9 April, 2001
LD-2001-0024

**SUBJECT: SUBMITTAL OF "-A" ACCEPTED VERSION OF CENPD-132, SUPPLEMENT 4-P
(ENCLOSURE 1 CONTAINS PROPRIETARY INFORMATION)**

CENPD-132, SUPPLEMENT 4-P-A
CALCULATIVE METHODS FOR THE CE NUCLEAR POWER
LARGE BREAK LOCA EVALUATION MODEL

Figure 1-2
SG Secondary Side Pressure

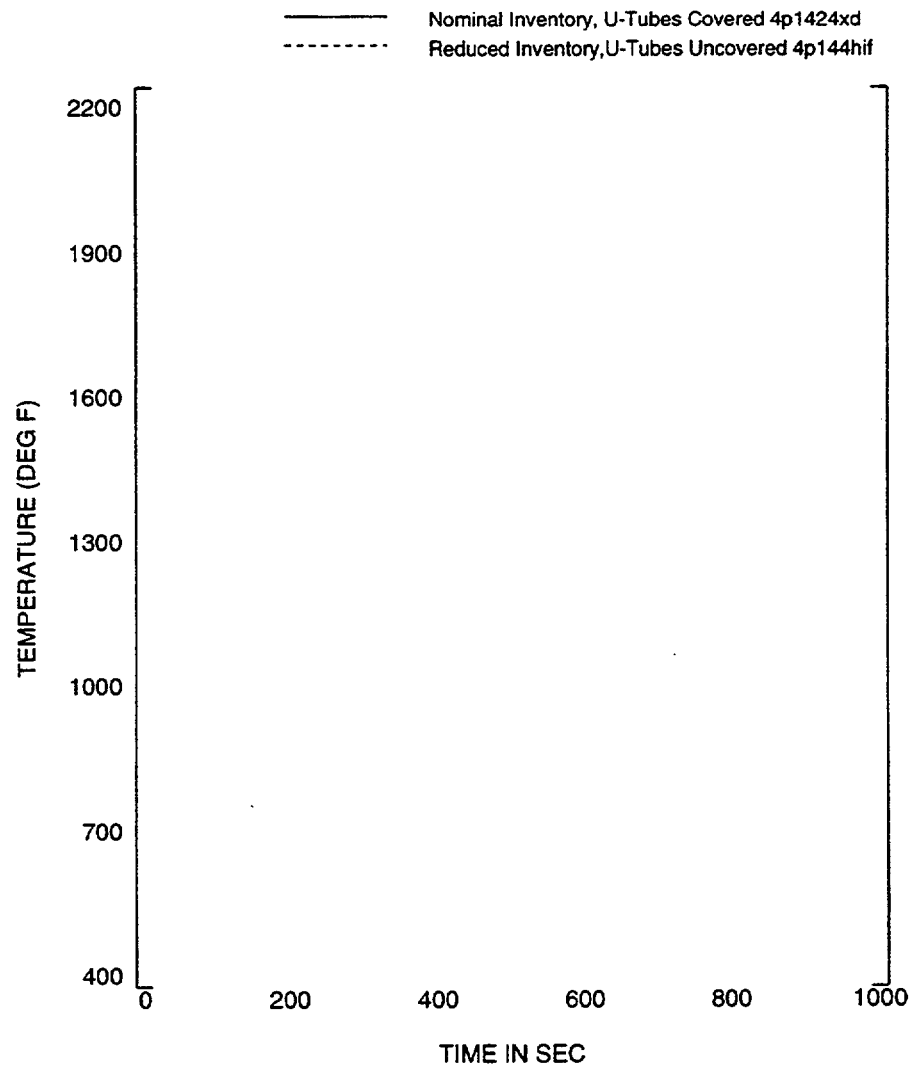
2. **CENP will evaluate the effects of neglecting the wall heat transfer to the SG secondary side steam region in the SG modeling.**
